# Access Compliance Report

### (Curb Ramps)

Intersection ID: 10018518	Main Street: DUMONT_LN	Cross Street: N/A	Location: S
ADA ID: F108924EEE06	Ramp Type: Perp	Initial Pass/Fail: Fail	Overall Compliance: No
Severity Score: 26.25			
Codes/Mitigation Info/Possible Solution		Field Measurements/Component Compliance

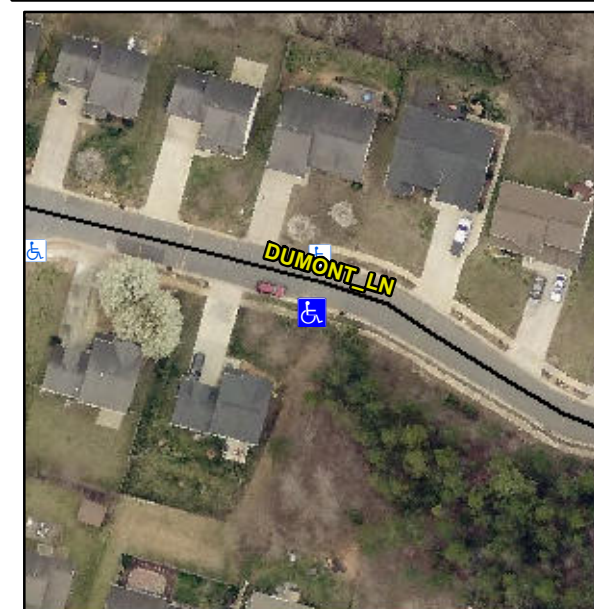
**Remove & Replace Entire Ramp.**

**R304.2.2, R304.5.3**

Compliance	Description	Data	Compliance	Description	Data
N/A	Ramp Length (in)	48.0	No	Ramp Slope (%)	14.8
Yes	Ramp Width (in)	49.0	No	Ramp XSlope (%)	3.8
N/A	Flare Type LT	N/A	N/A	Flare Type RT	N/A
N/A	Flare Slope LT (%)	N/A	N/A	Flare Slope RT (%)	N/A
N/A	Flare Traversable LT?	N/A	N/A	Flare Traversable RT?	N/A
N/A	Landing Length (in)	N/A	N/A	DWS Provided?	N/A
N/A	Landing Width (in)	N/A	N/A	DWS Contrast?	N/A
N/A	Landing Slope (%)	N/A	N/A	DWS Length (in)	N/A
N/A	Landing X Slope (%)	N/A	N/A	DWS Full Width?	N/A
N/A	Landing Curb? (Y/N)	N/A	N/A	DWS Offset (in)	N/A
N/A	Shared Landing?	N/A			
N/A	Gutter Ponding?	N/A	N/A	Gutter Slope (%)	N/A
N/A	Gutter Lip Ht (in)	N/A	N/A	Gutter X Slope (%)	N/A
N/A	Painted X Walk1?	No	N/A	Painted X Walk2?	N/A
	X Walk 1 Direction	To N		X Walk 2 Direction	N/A
N/A	X Walk 1 Width (in)	N/A	N/A	X Walk 2 Width (in)	N/A
	X Walk 1 Slope (%)	1.4		X Walk 2 Slope (%)	N/A
	X Walk 1 X Slope (%)	2.7		X Walk 2 X Slope (%)	N/A
